Quad Cities Nuclear Power Station, Units 1 and 2
Renewed Facility Operating License Nos. DPR-29 and DPR-30
NRC Docket Nos. 50-254 and 50-265

Subject: Additional Information Regarding Request for License Amendment to Revise Technical Specifications Section 5.5.12 for Permanent Extension of Type A and Type C Leak Rate Test Frequencies

QC-LAR-04, "Quad Cities ILRT RAI Response"

Figure 5-1
Pre-Existing Containment Failure Model Logic

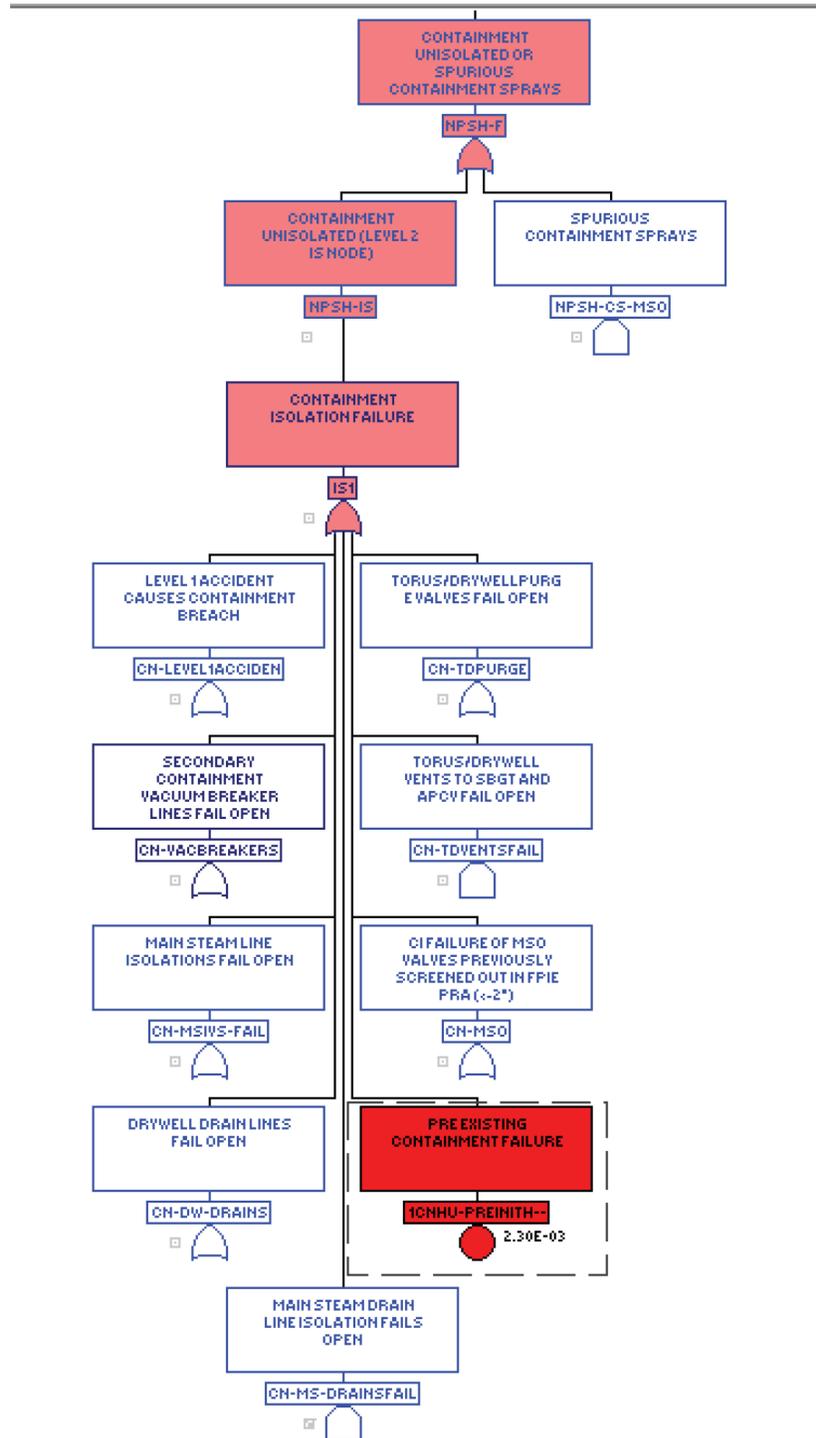
- b) Describe and justify the PRA modeling and methodology used in the LAR to estimate Δ CDF due to loss of containment overpressure. The LAR states that the containment isolation failure was increased by the frequency of Class 3b in order to derive Δ CDF. Containment isolation failure is typically linked to LERF, so it is not immediately clear to the NRC staff how increasing containment isolation failure probability would produce a change in CDF.
- c) If a new estimate of Δ CDF results from items a) and b) above, estimate the contribution to Δ LERF resulting from loss of containment overpressure impact on the ECCS pump performance, including the contribution from loss of containment overpressure to the risk from external hazards. Describe and justify the method used for estimating Δ LERF.

The QC FPIE Level 1 PRA model used to support the LAR includes loss of NPSH logic under gate NPSH-F. A pre-existing leak is one of many events that are modeled to impact NPSH with a loss of SPC and SDC. Gate NPSH-F is under gate ECCS-NPSH and may lead to loss of low pressure injection from Core Spray (CS) and RHR systems, if coupled with failure to provide containment heat removal early in the event, as shown in Figure 5-1.
